SUBJECT: **ADDENDUM #1 TO THE BIDDING DOCUMENTS FOR:
NORTH HIGH SCHOOL BID GROUP#01**
NORTH AND SOUTH HIGH SCHOOL HVAC PROJECT 2022
COMMUNITY HIGH SCHOOL DISTRICT 99
NORTH HIGH SCHOOL
4436 MAIN STREET
DOWNERS GROVE, IL 60516
SOUTH HIGH SCHOOL
1436 NORFOLK STREET
DOWNERS GROVE, IL 60516

This addendum forms a part of the Bidding Contract Documents, dated November 30th, 2021. Bidders must acknowledge receipt of this Addendum in the space provided on the Bid Form.

- Mechanical Drawings:
MD2.02E.S;M2.02E.S;M5.02.S
- Electrical Drawings:
E2.02E.S; E2.04G.S; E2.04H.S;E3.00S; ED2.02E.S; ED2.04G.S; ED2.04H.S
- Question and Answer Log
- 004100 HVAC Scope
- 004101 HVAC Bid Form

**MECHANICAL PIPE
FLOOR PLAN MEZZANINE
LEVEL AREA E-DGS**

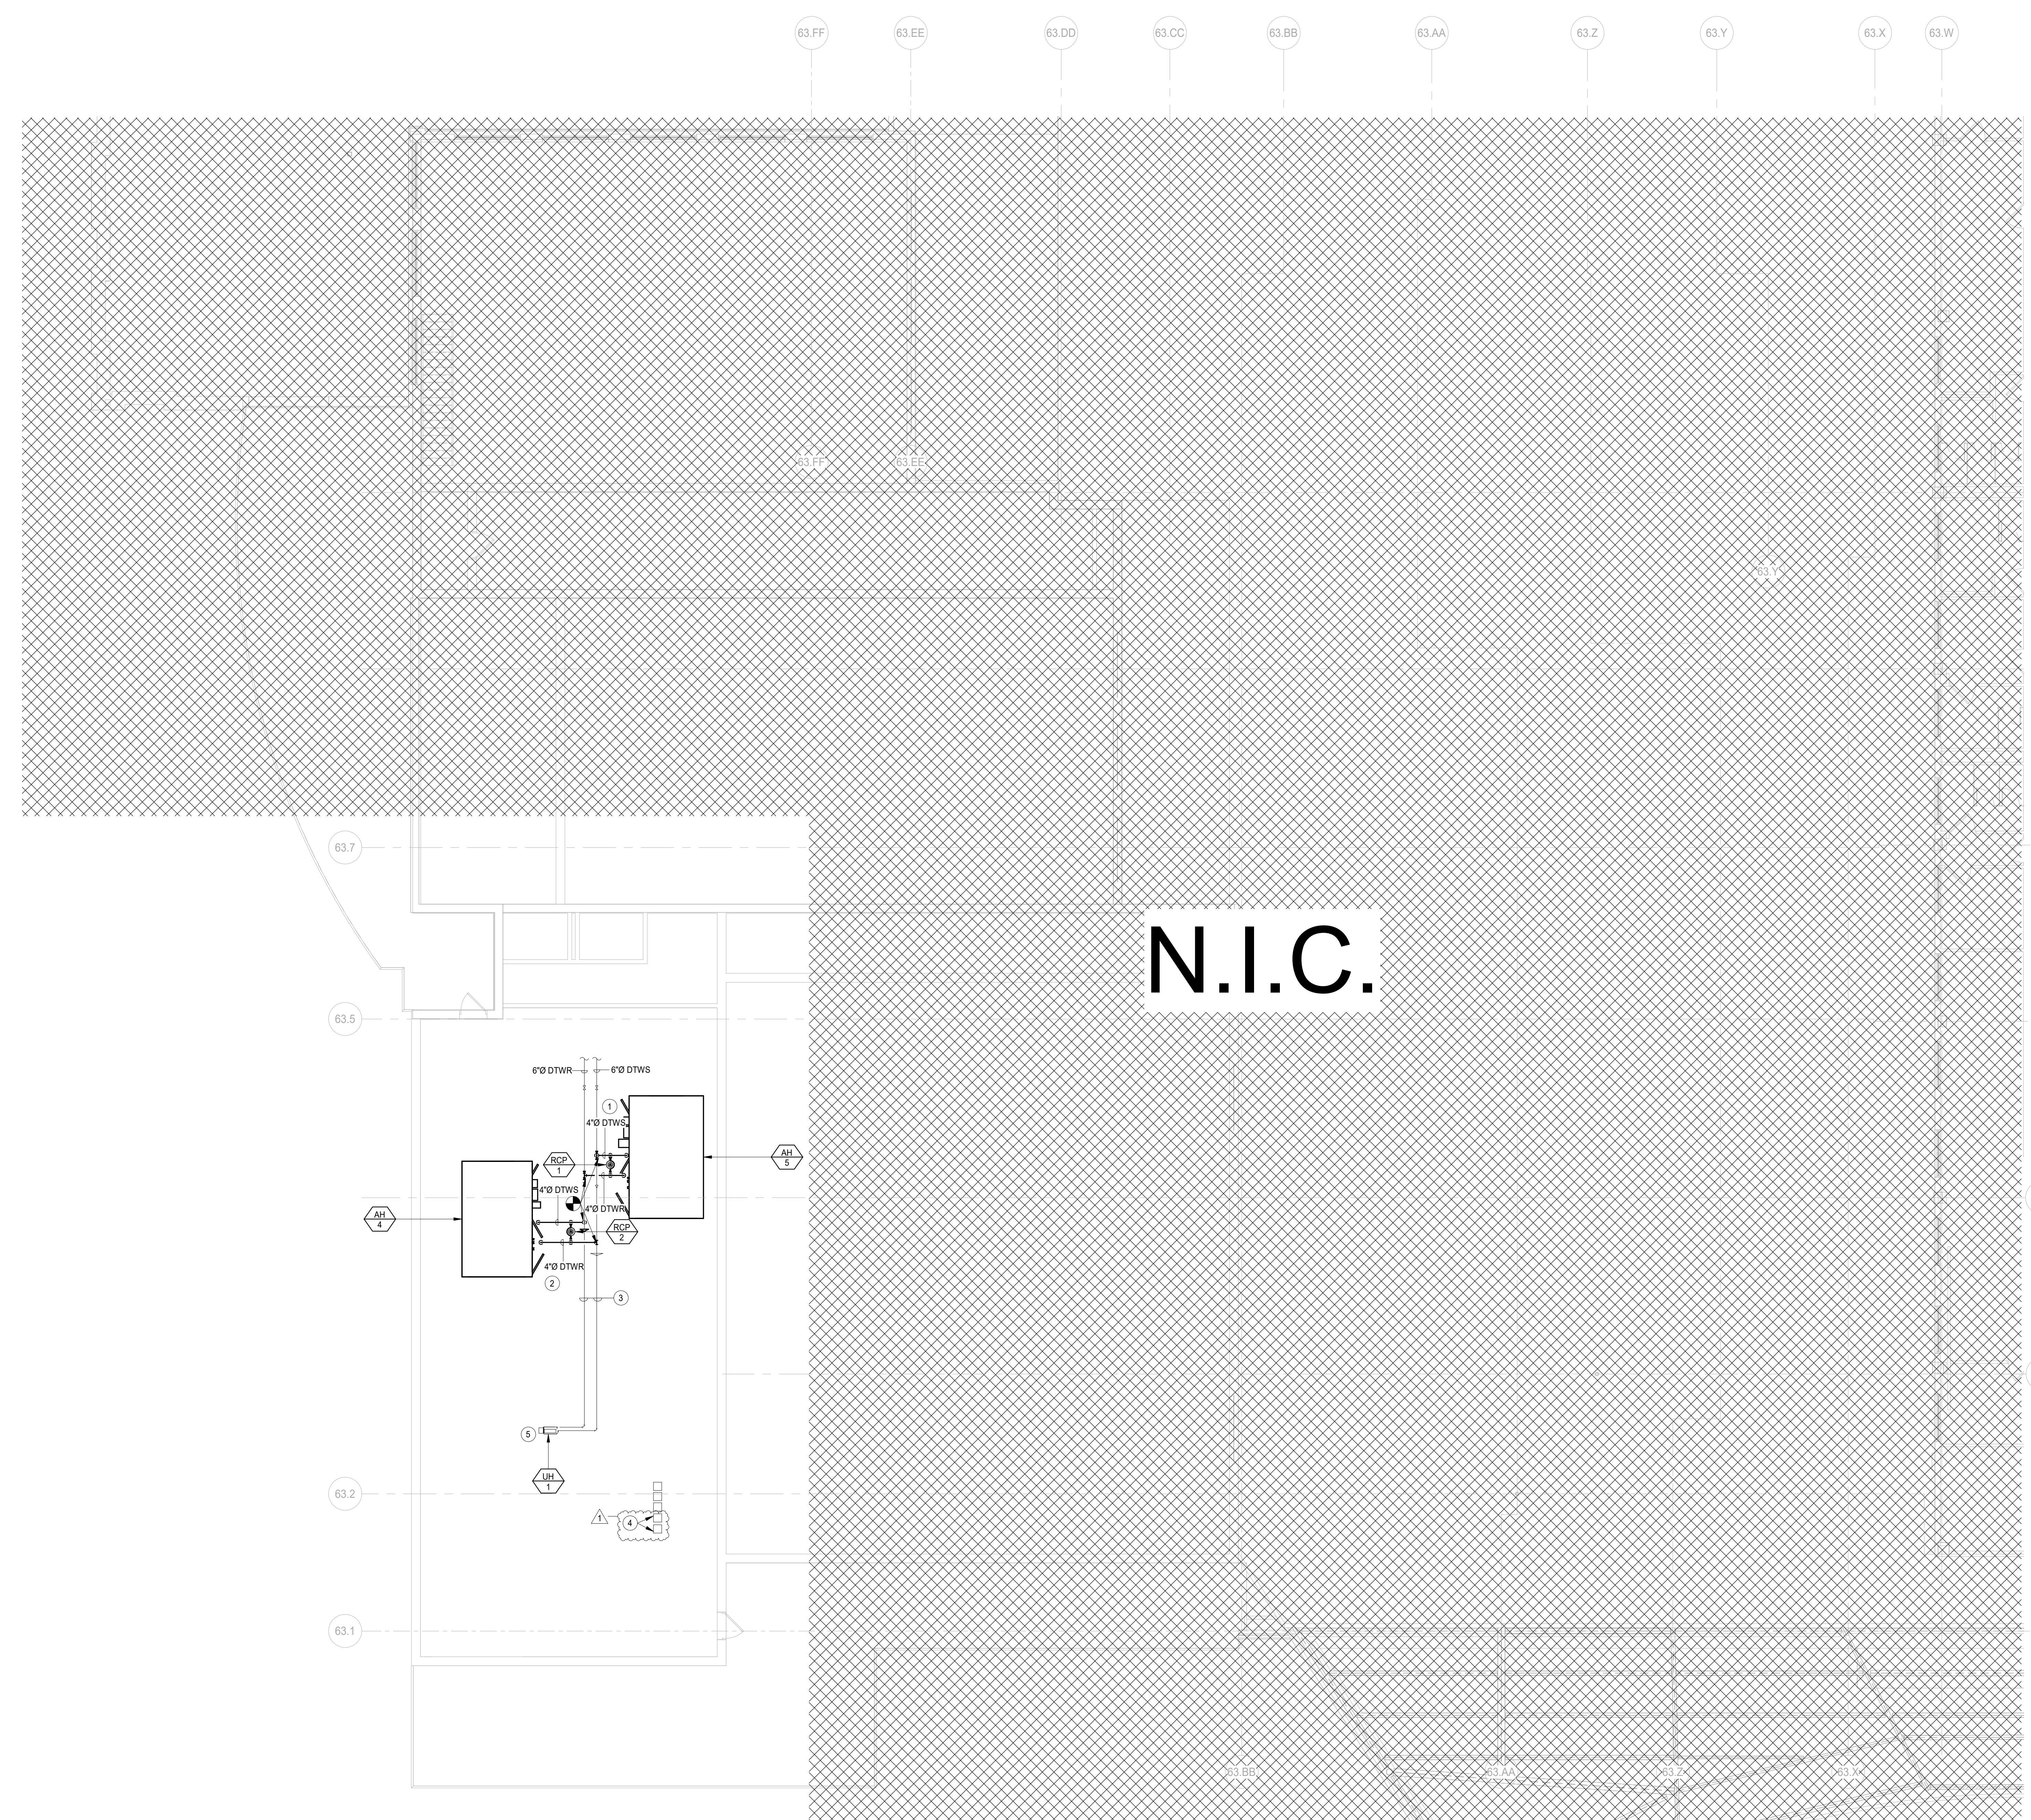
1. PROVIDE NEW DUAL TEMPERATURE SUPPLY AND RETURN PIPING TO THE DUAL TEMPERATURE COIL IN AHS. PROVIDE ALL NEW VALVES AND GAGES. PROVIDE NEW RECIRC PUMP. REFER TO DETAILS FOR MORE INFORMATION.
2. PROVIDE NEW DUAL TEMPERATURE SUPPLY AND RETURN PIPING TO THE DUAL TEMPERATURE COIL IN AHS. PROVIDE ALL NEW VALVES AND GAGES. PROVIDE NEW RECIRC PUMP. REFER TO DETAILS FOR MORE INFORMATION.
3. EXISTING DUAL TEMPERATURE SUPPLY AND RETURN PIPING TO REMAIN. REUSE EXISTING DISCONNECT SWITCHES FOR NEW RECIRC PUMPS.
4. EXISTING UNIT HEATER TO REMAIN.

Sheet:
E2.04G.S

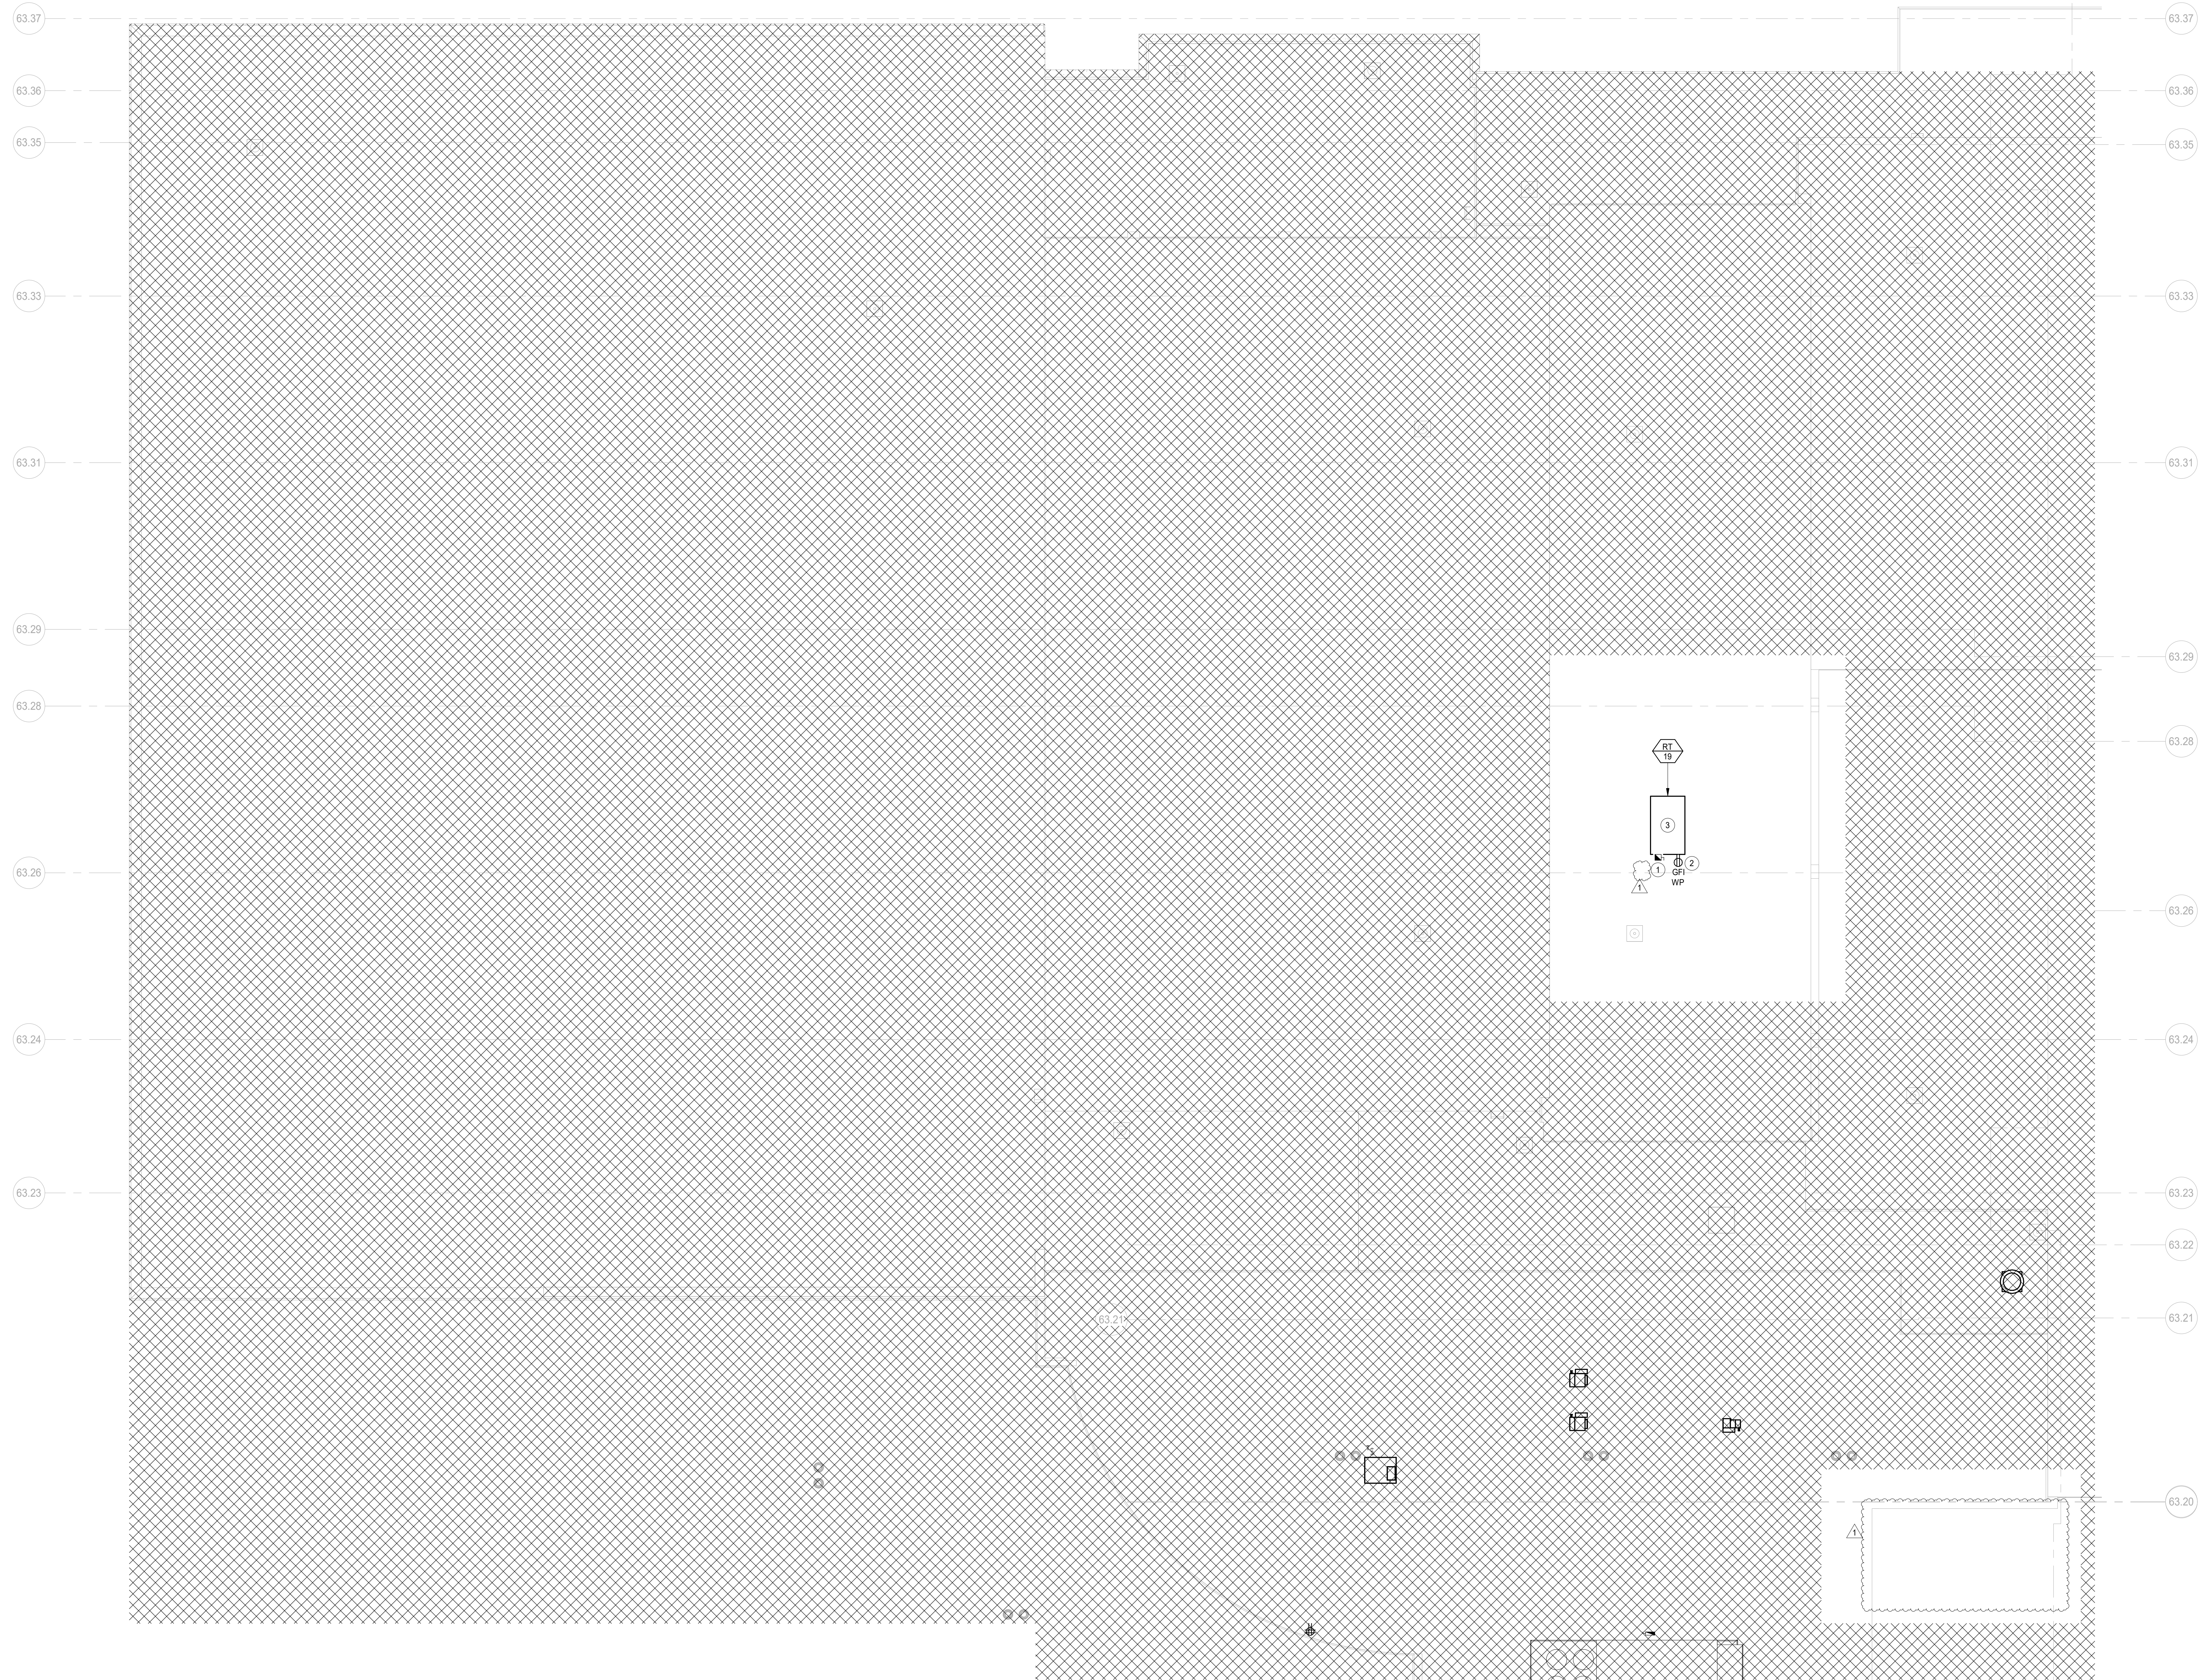
1. PROVIDE AND INSTALL NEW 80% NEMA 3R FUSED DISCONNECT SWITCH. CONNECT NEW DISCONNECT TO EXISTING FEED. INTERCEPT AND EXTEND WIRING AND CONDUIT AS REQUIRED. VERIFY EXACT CONDITIONS IN FIELD. SEE MECHANICAL SCHEDULES FOR MORE INFORMATION.
2. CONNECT NEW DUPLEX RECEPTACLE TO EXISTING RECEPTACLE CIRCUIT SERVING THE AREA. INTERCEPT AND EXTEND EXISTING CABLES AND CONDUIT AS REQUIRED. VERIFY EXACT CONDITIONS IN FIELD. PROVIDE WEATHER PROOF COVER.
3. PROVIDE NEW DUCT SMOKE DETECTORS IN THE SUPPLY AND RETURN AIR DUCTS. UTILIZE EXISTING CIRCUIT SERVING THE EXISTING DUCT SMOKE DETECTORS. INTERCEPT AND EXTEND ALL CABLES AND CONDUIT AS REQUIRED. VERIFY EXACT CONDITIONS IN FIELD. SEE MECHANICAL DRAWINGS FOR MORE INFORMATION.
